Access Compliance Report

Public Rights-of-Way

(Curb Ramps)

Intersection ID: 18488	Main Street: ABBEY_PL	Cross Street: PARK_RD	Location: NE
ADA ID: E4486617F02B	Ramp Type: Perp	Initial Pass/Fail: Pass	Overall Compliance: No
		Severity Score: 0

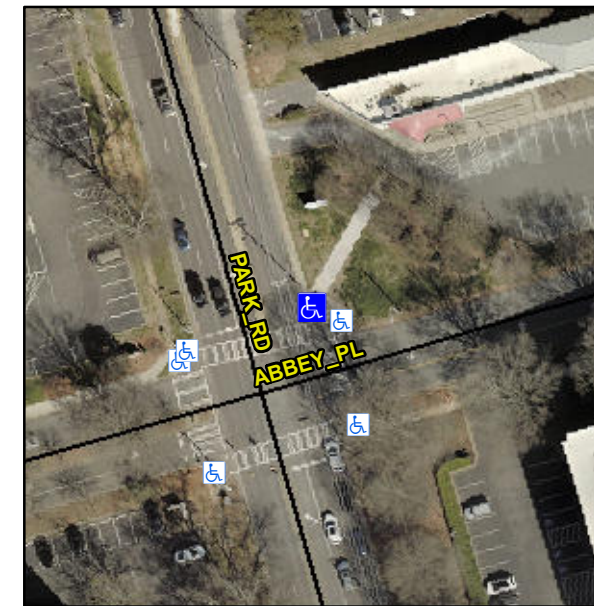
**Remove & Replace Entire Ramp.
Restripe Crosswalk.**

**R304.2.2-Perp, R304.3.2-Para,
R305.2, R207.1**
